Title of Change:	MLP33 Case Outline Lead Length "L" and Lead DAP Length "G" Dimension Tolerance Change
Effective date:	01 Apr 2022
Contact information:	Contact your local onsemi Sales Office or Godfrey.Valles@onsemi.com
Type of notification:	This Product Bulletin is for notification purposes only. onsemi will proceed with implementation of this change upon publication of this Product Bulletin.
Change Category:	Documentation
Change Sub-Category(s):	Datasheet/Product Doc change

DOCUMENT NUMBER:	98AON13650G	Electronic versions are uncontrolled except when accessed directly from the Document Repository. Printed versions are uncontrolled except when stamped "CONTROLLED COPY" in red.
DESCRIPTION:	WDFN8 3.3x3.3, 0.65P	PAGE 1 OF 1

Old Case Outline Drawing:

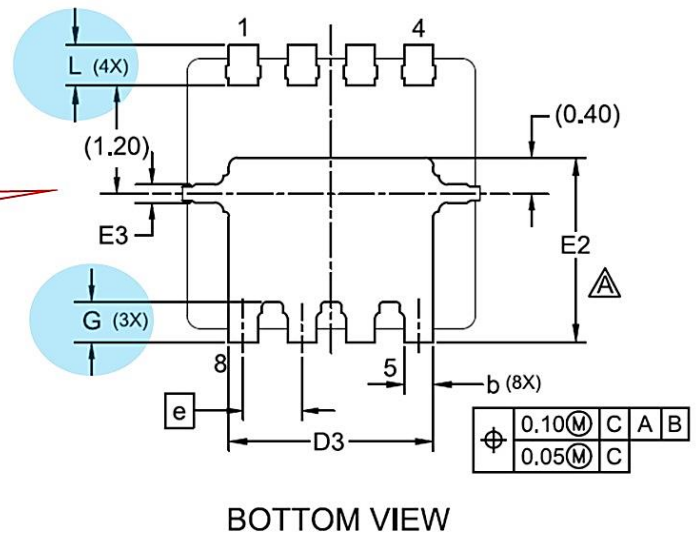
Changed Lead Length (dimension L) and Lead DAP Length (dimension G) to 0.40 +/- 0.10 mm (using JEDEC Standard Tolerance) of 511DR Case Outline. For Reference Case Outline/Dimension Alignment.

E3	0.15	0.20	0.25
e	0.65 BSC		
G	0.40	0.45	0.50
L	0.40	0.45	0.50
Ø	0	-	12
